STATE OF OHIO DEPARTMENT OF TRANSPORTATION

SUM-241-1.50/VAR

RESURFACING OF SUM SR 241, INCLUDES URBAN PAVING IN THE CITY OF GREEN, AND MINOR WORK TO 1 STRUCTURE.

2025

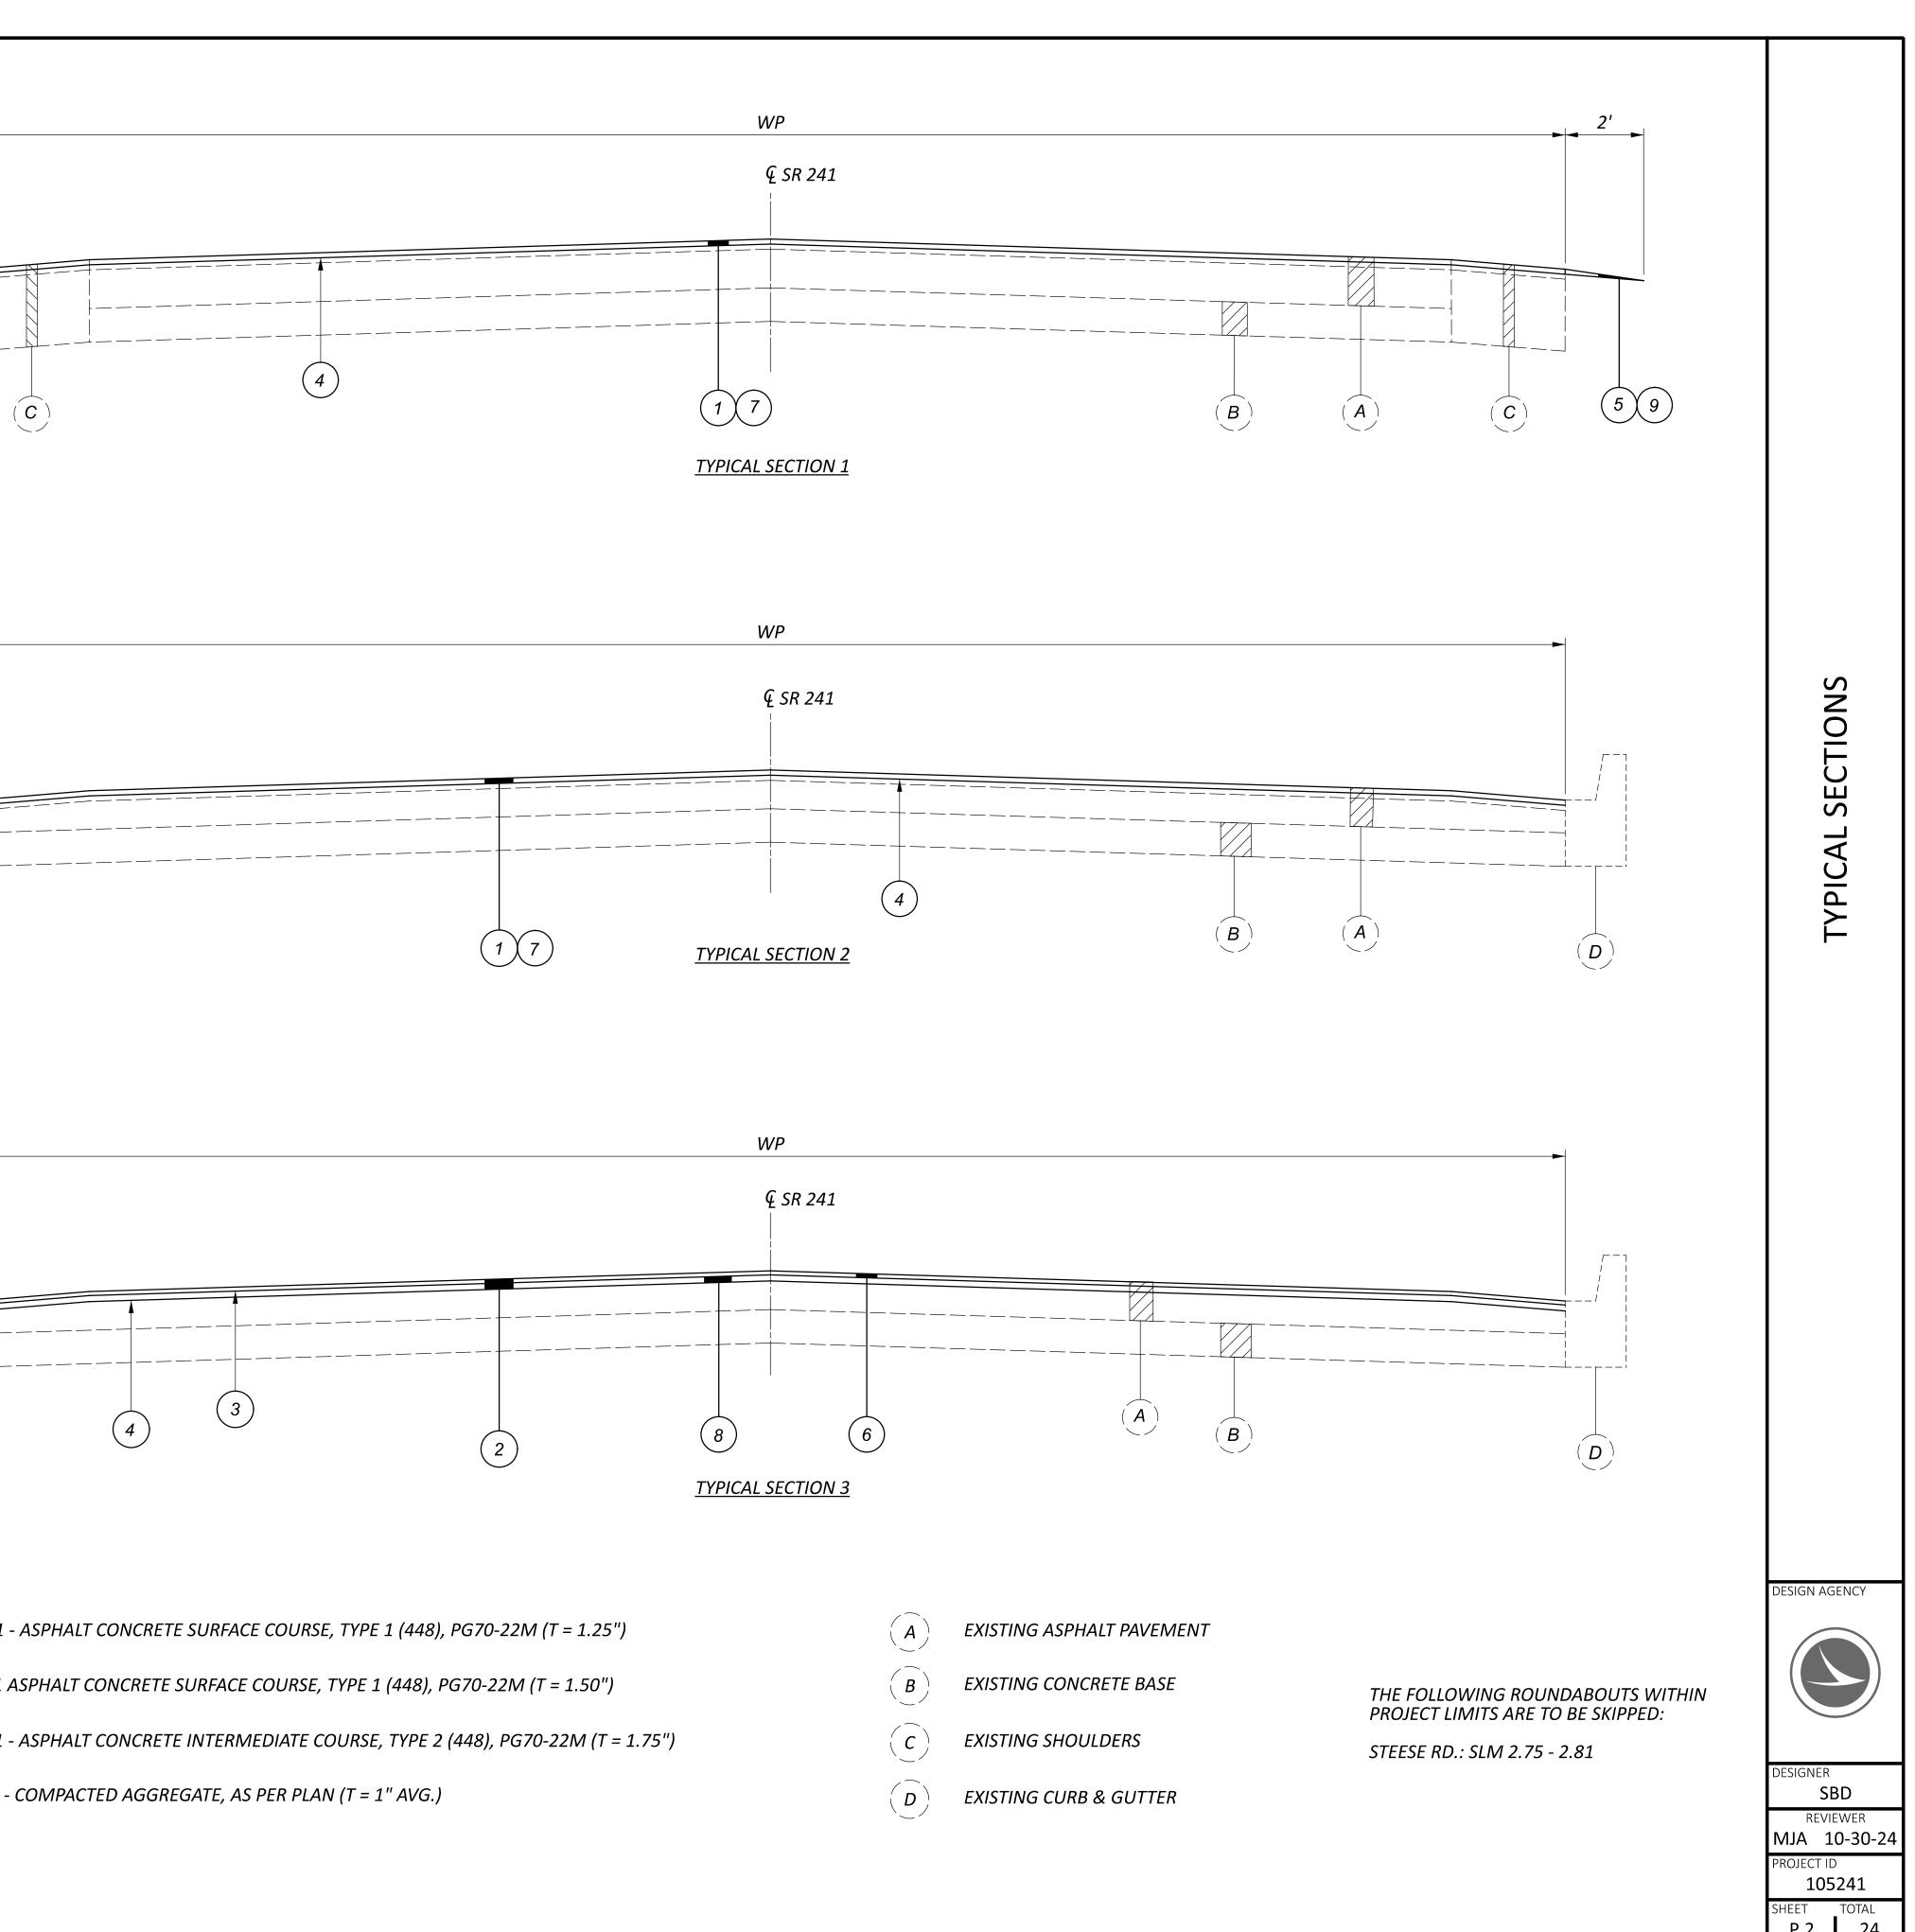
TYPICAL	SECTION	#1 (NO C	URB, IN C	ITY OF GREEN)				
ROUTE	SL	M	LENGTH	WP				
ROUTE	FROM	ТО	(MILES)	(FEET)				
241	1.50	1.54	0.04 🗸	~30~				
241	1.79	2.55	0.76	31				
241	4.74	5.63	4.89	31				
TOTAL = 1.69 MILES								
mint !!								
				Revised

<u> </u>	Revised
	Revised

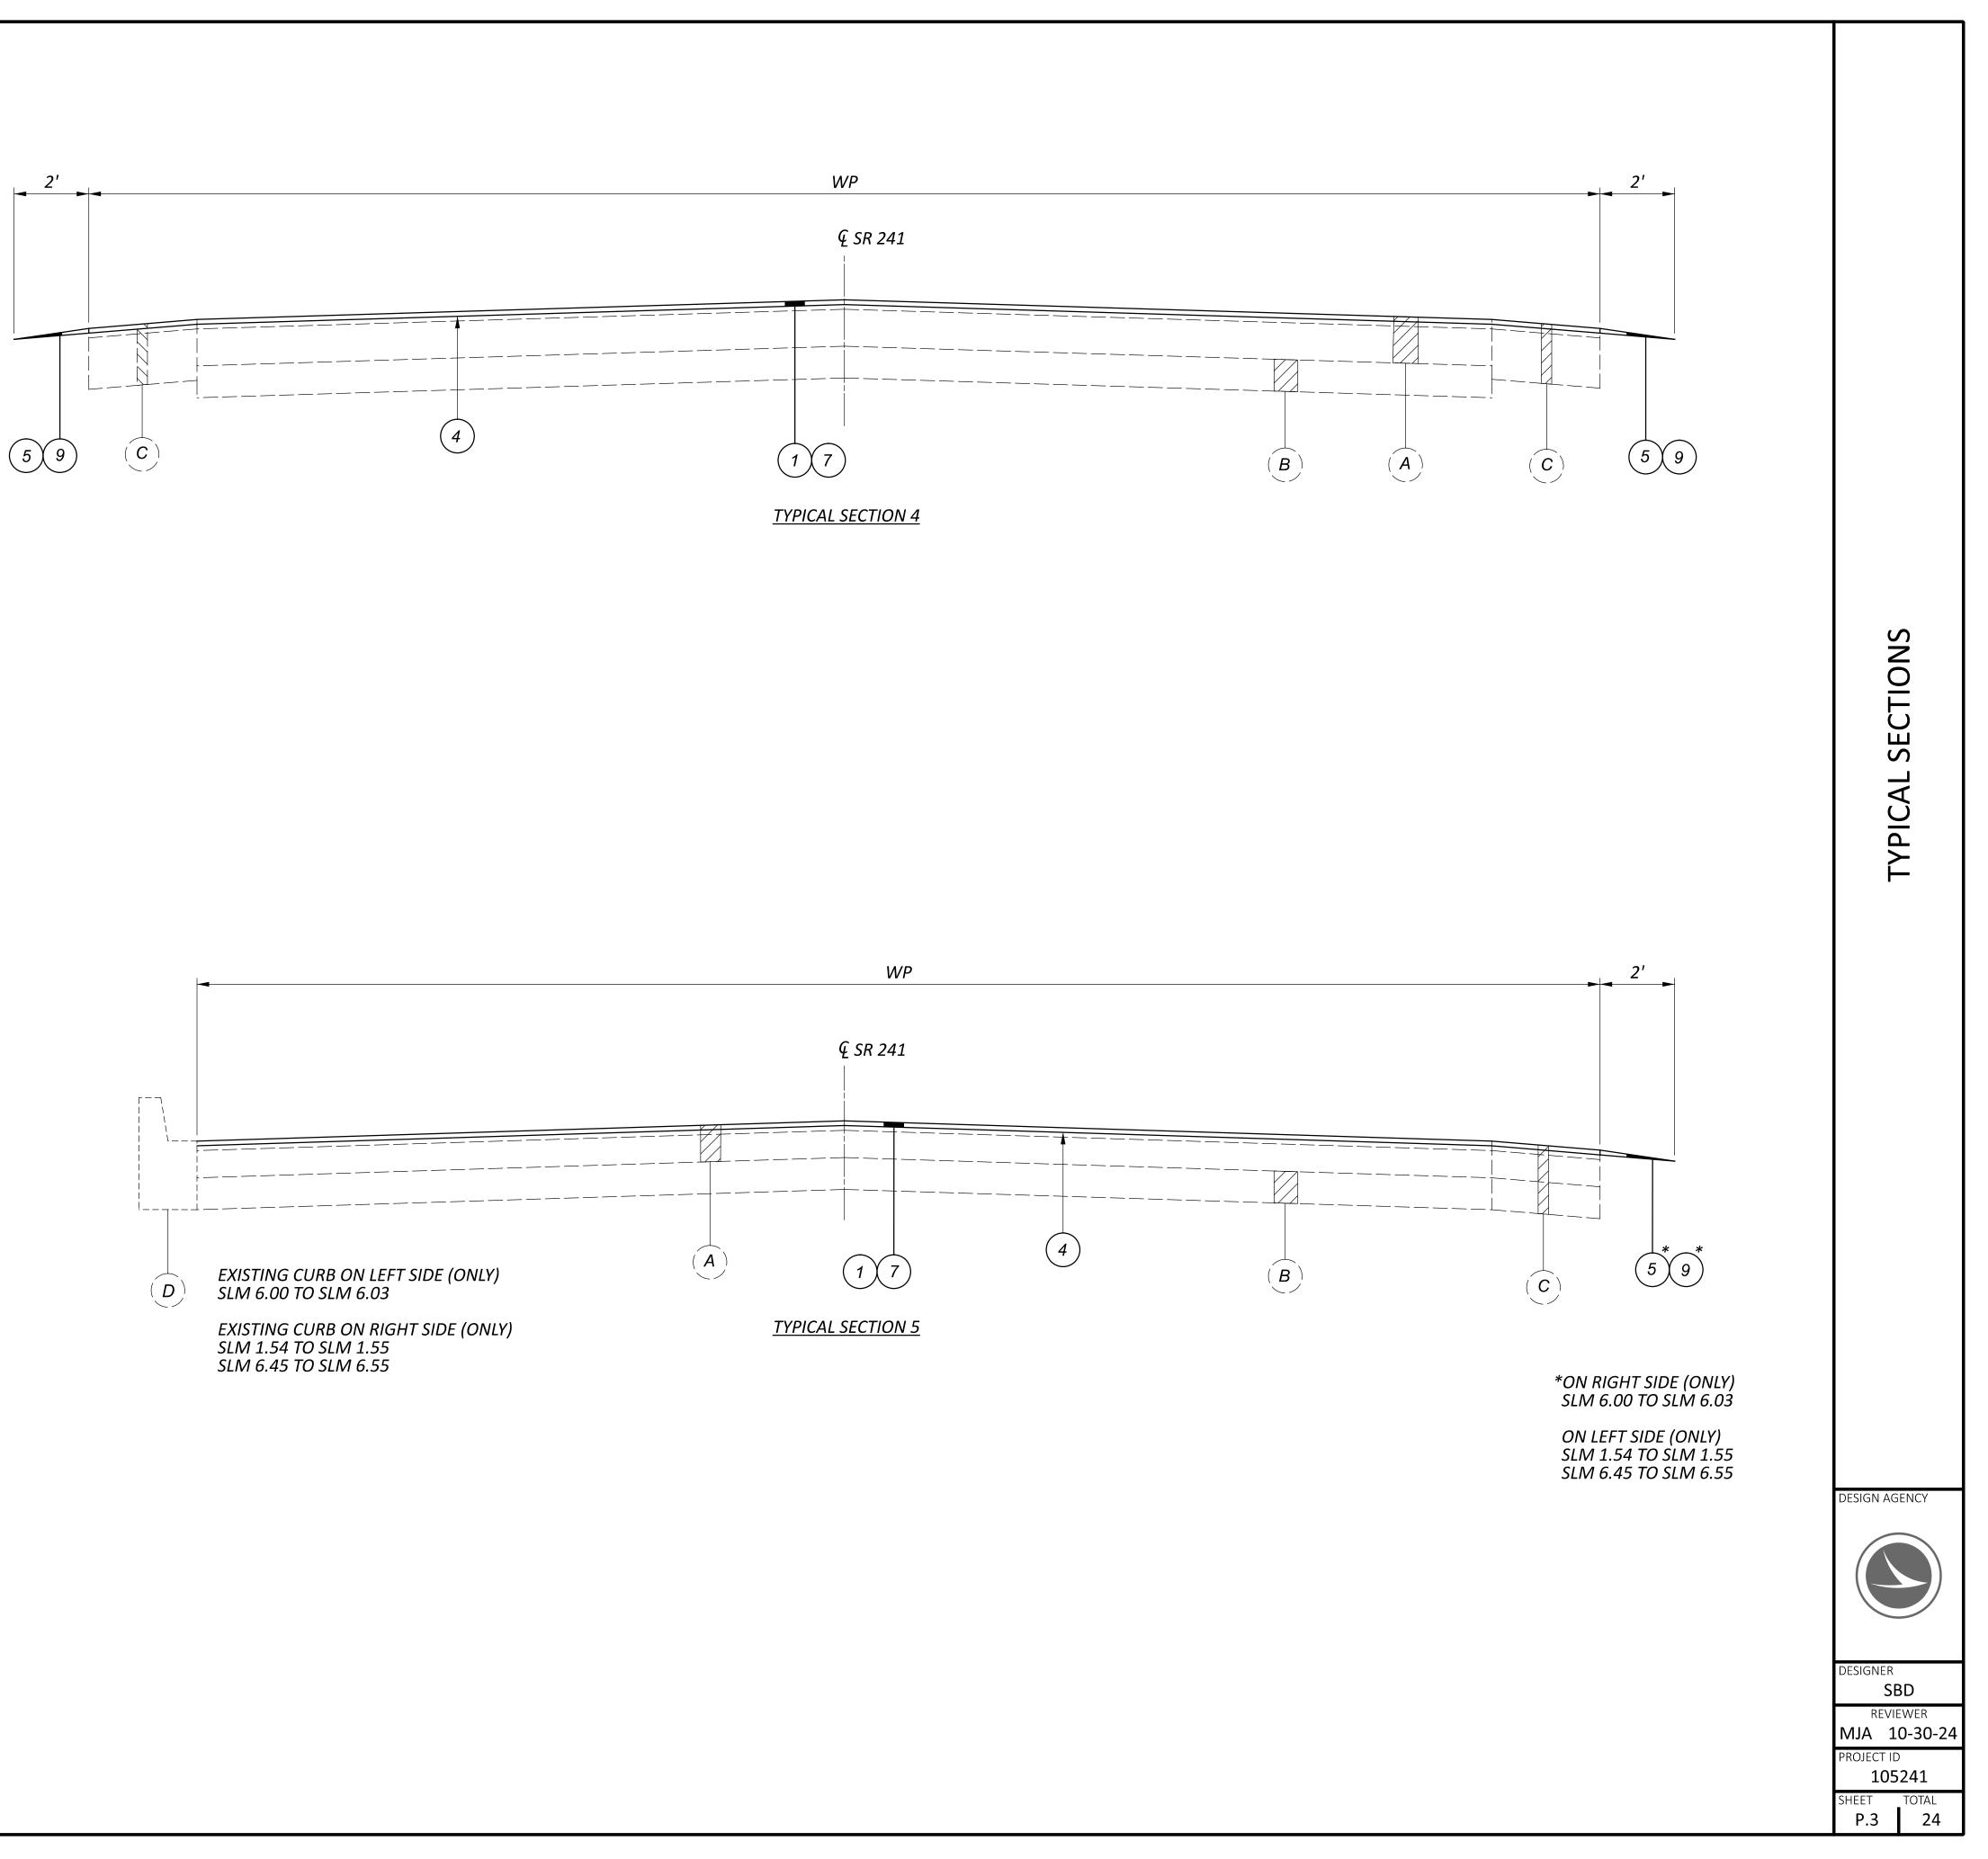
ROUTE	SLM		LENGTH	WP	
NOOTE	FROM	ТО	(MILES)	(FEET)	
241	5.63	5.90	0.27	32	
241	~5x9Q~	~6.00 ~	~0.10~	~~~~~~~~~~~~~~~~~~~~~~~~~~~~~~~~~~~~~~~	
241	6.09	6.15	0.07	44	
241	6.15	6.22	0.07	45	
241	6.22	6.35	0.13	und the second	
241	6.35	6.45	0.10	56	
241	6.55	6.62	0.07	56	
241	6.62	6.71	0.09	47	
241	6.71	6.80	0.09	32	
241	6.80	6.85	0.05	41	
241	6.90	6.92	0.02	41	
241	6.92	6.99	0.07	34	
241	6.99	7.37	0.38	31	
241	7.37	7.48	0.11	39	
241	7.48	7.53	0.05	41	
241	7.53 (~7.79~	0.26	34	
	ζ	TOTAL =	1.92 MILE	ES {

TYPICAL SECTION #5						
ROUTE	SLM		LENGTH	WP		
ROOTL	FROM	ТО	(MILES)	(FEET)		
241	-1,54-	1.55	-0,01-	~3Pm		
241	6.00	6.07	0.07	40		
241	6.45	6.55	Q10 M	56		
TOTAL = 0.18 MILES						
- amonth /

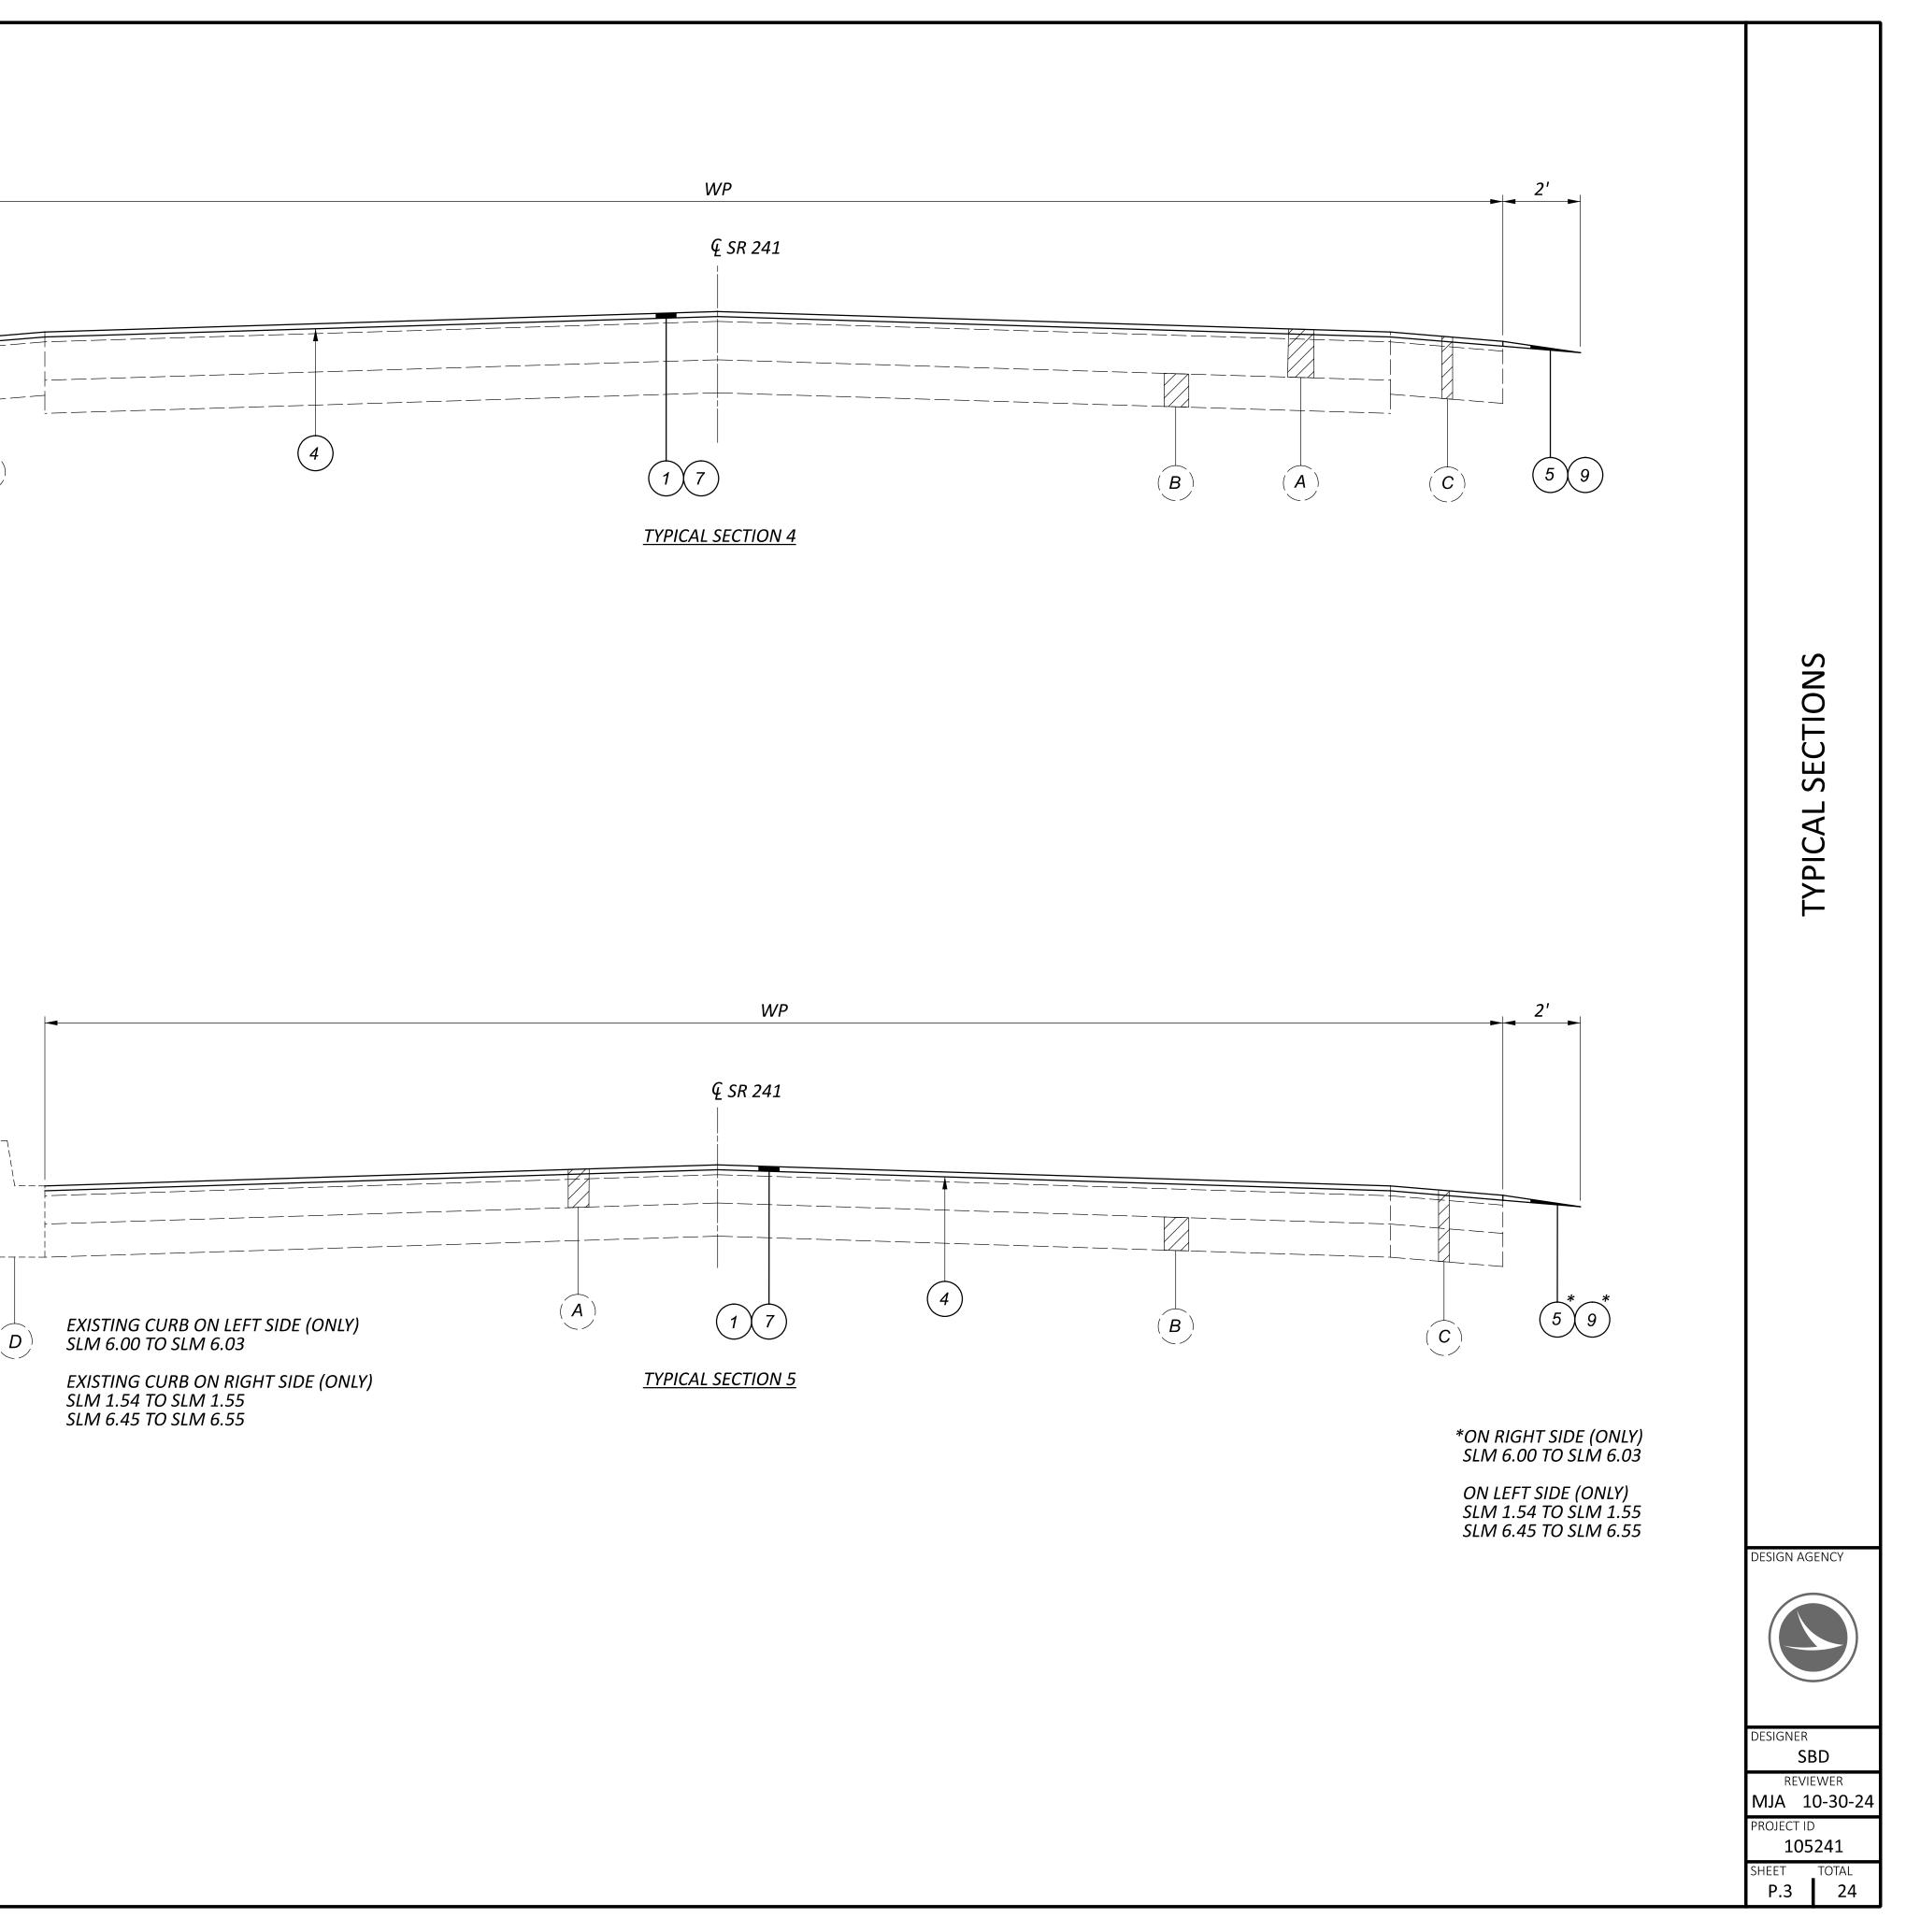
Revised
